Re: Comments on J.L. Storedahl & Sons Skamania Quarry Draft Environmental Impact Statement—Skamania County File No. SEP-21-15

RE: Skamania Quarry Draft Environmental Impact Statement – Noise Critique

Figure 1: Map of Salmon Falls Road Roadway Grade

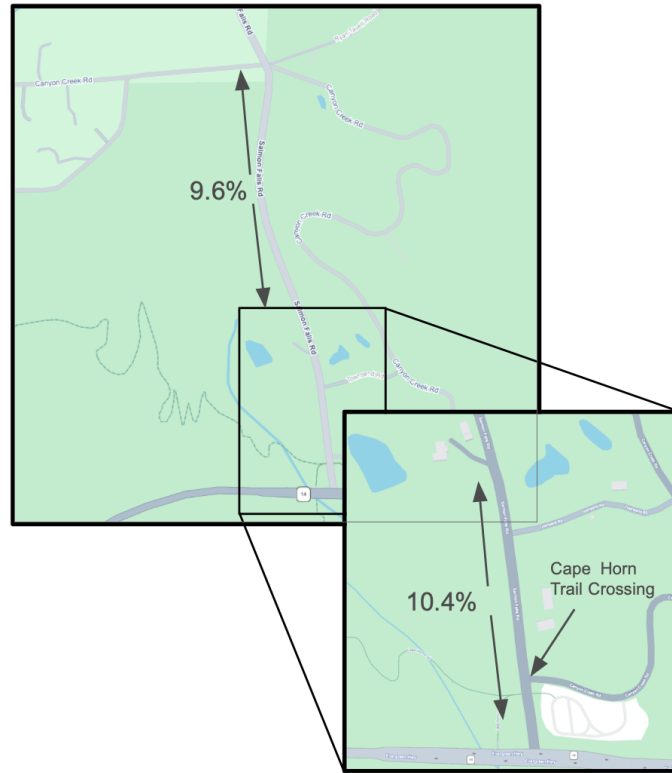
The TIS defines a 6% downgrade on Salmon Falls Road and an 85th percentile speed of 43 mph. However, upon further inspection, the downgrade on Salmon Falls Road as it approaches the crossing of the Cape Horn Trail averages approximately 9.6% and increases to an approximately 10.4% downgrade within 750 feet of the pedestrian crossing - see figure 1. Additionally, the speed data was collected north of Canyon Creek Road on a relatively flat section of Salmon Falls Road. There, the southbound approach to the intersection of Salmon Falls Road and Canyon Creek Rd was measured with an 85th percentile speed of 44mph - one mile per hour faster than is used in the TIS. Combined with the downgrade south of Canyon Creek Road, the 85th percentile speed should be assumed to be higher than the measured 44mph.
